**Cumberland County Subdivision and Land Development Review Report**

Municipality:	<u>Hampden</u>	Surveyor/ Engineer:	<u>Mellott Engineering, Inc.</u>	Owner/ Developer:	<u>Golf Enterprises</u>
Plat Title:	<u>2130 Lambs Gap Road</u>				
Plat Status:	<u>Preliminary/Final</u>	Plat Type:	<u>Subdivision</u>		
# of New Lots:	<u>7</u>	# of New Dwelling Units:	<u>6</u>	New Acreage Subdivided/Developed:	<u>6.21</u>
				Total Tract Acreage:	<u>6.21</u>
Zoning District:	<u>RC</u>	Proposed Land Use:	<u>Residential</u>		
Date Received:	<u>4/20/2020</u>	County Review:	<u>4/24/2020</u>	Reviewed by:	<u>EG</u>
				Checked by:	<u></u>

# PRELIMINARY/FINAL SUBDIVISION PLAN

# 2130 LAMBS GAP ROAD

No.	REVISION	DATE	MELLOTT ENGINEERING, INC.	DRAWING ID	201948 COV
1	-	-	Copyright © 2020	DATE:	April 20, 2020
2				SHEET	1 OF 9
3					
4

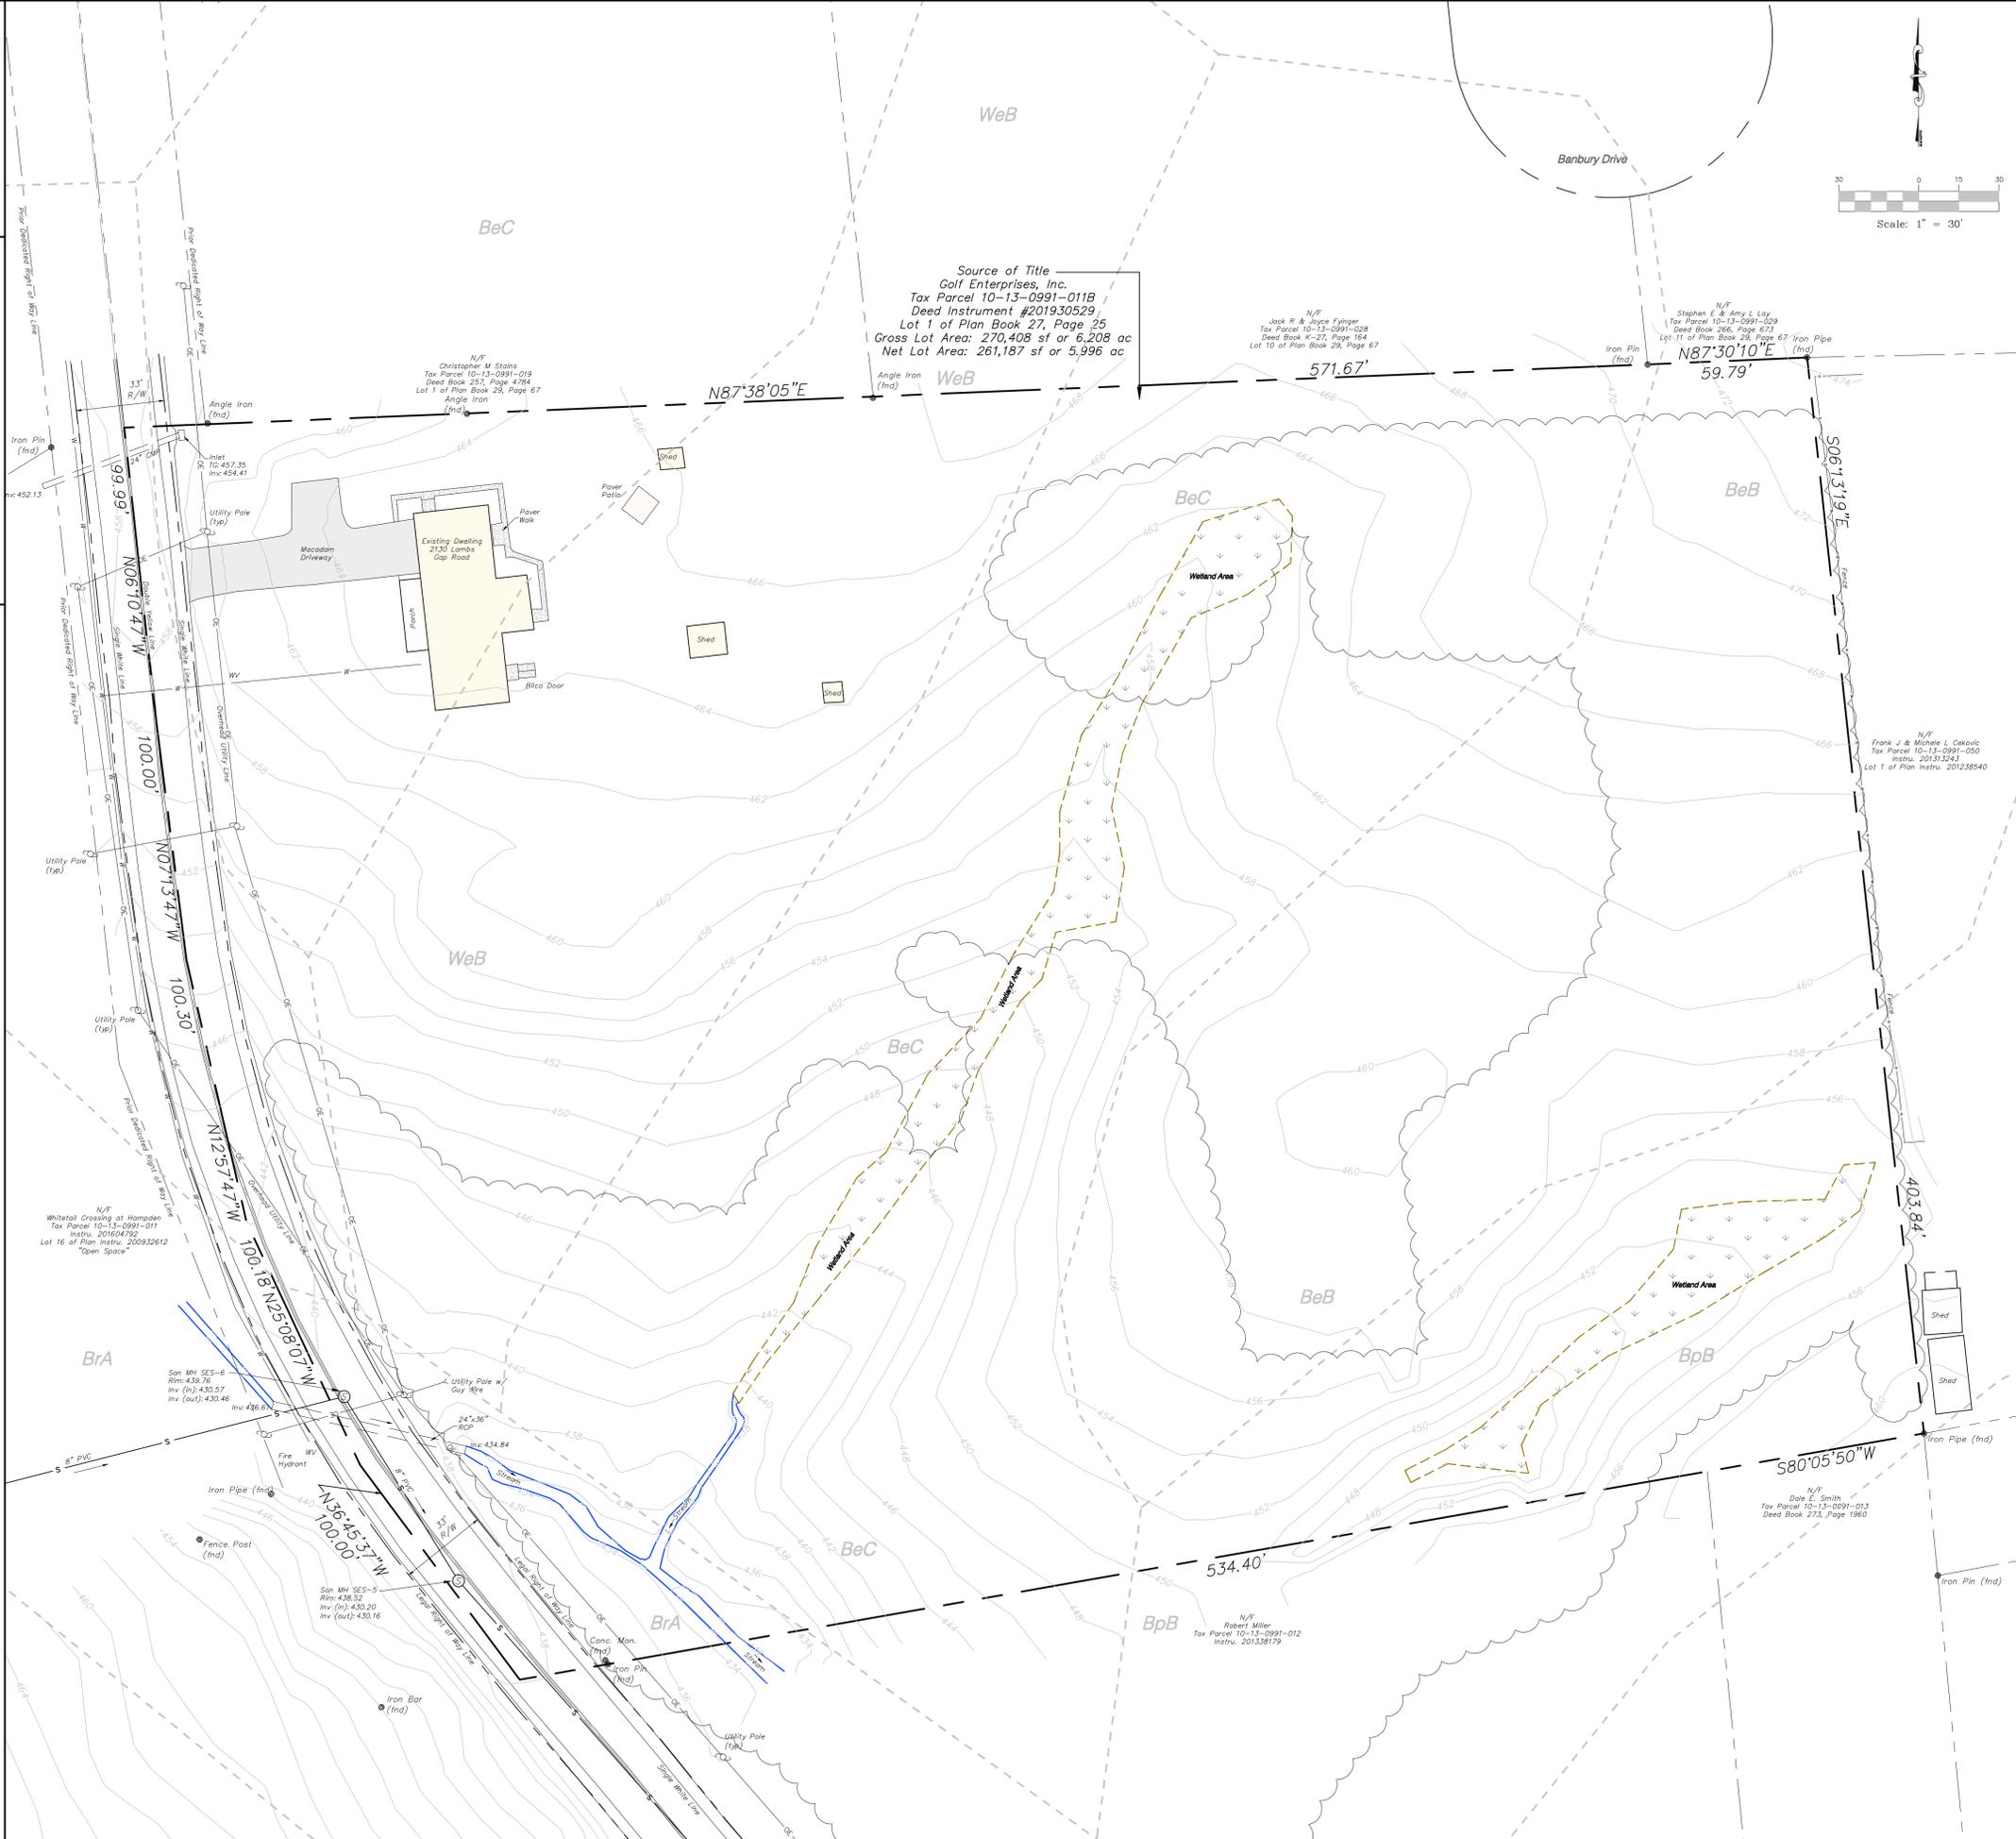
1. Some of the information provided on the Cover Sheet pertaining to utility providers is illegible and should be corrected.
2. A demolition plan for the existing dwelling, impervious surfaces and accessory structures should be shown on the plan.

Project No. 201948  
 Date April 20, 2020  
 Sheet No. **3 of 9**

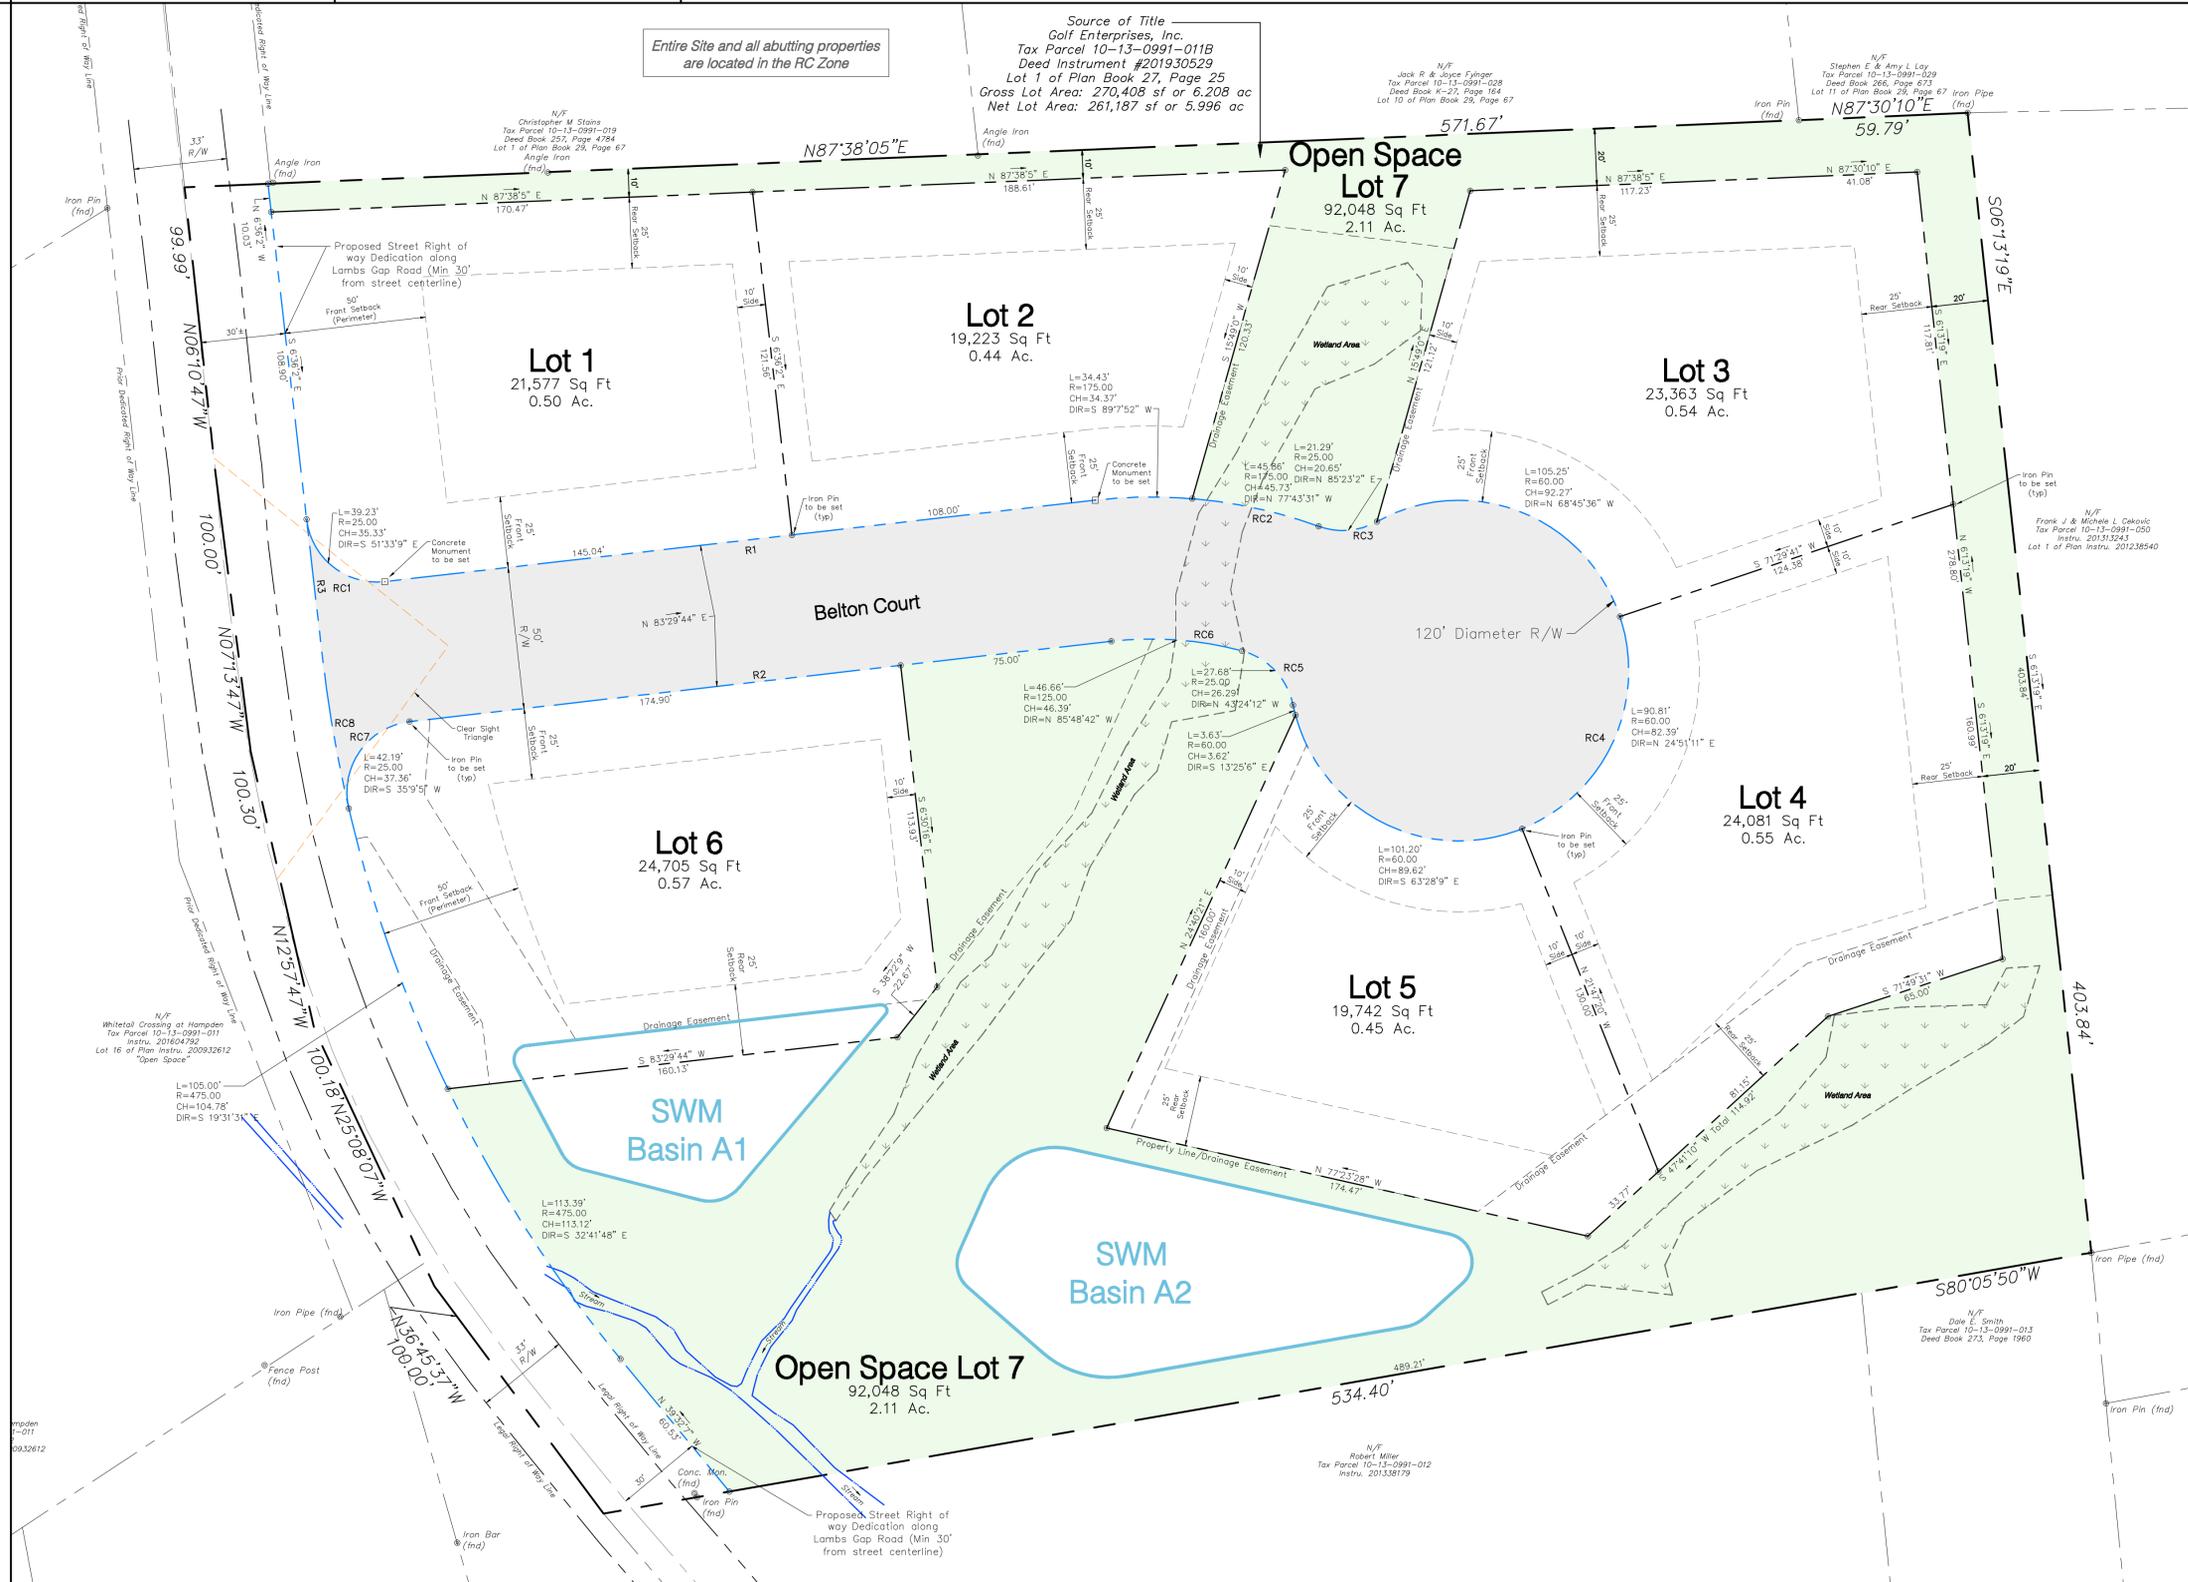
3. The township should verify whether the fee in lieu of dedication is applicable to five or six dwelling units.
4. Open space guidelines refer to building setback lines on the perimeter of the property that are required to follow the underlying zoning district guidelines. The Township should verify that the perimeter refers only to the area of the subdivision accessing the existing public street and is not applicable to all property lines on the outer edge of the development. (Zoning 1820.2.A.1a)
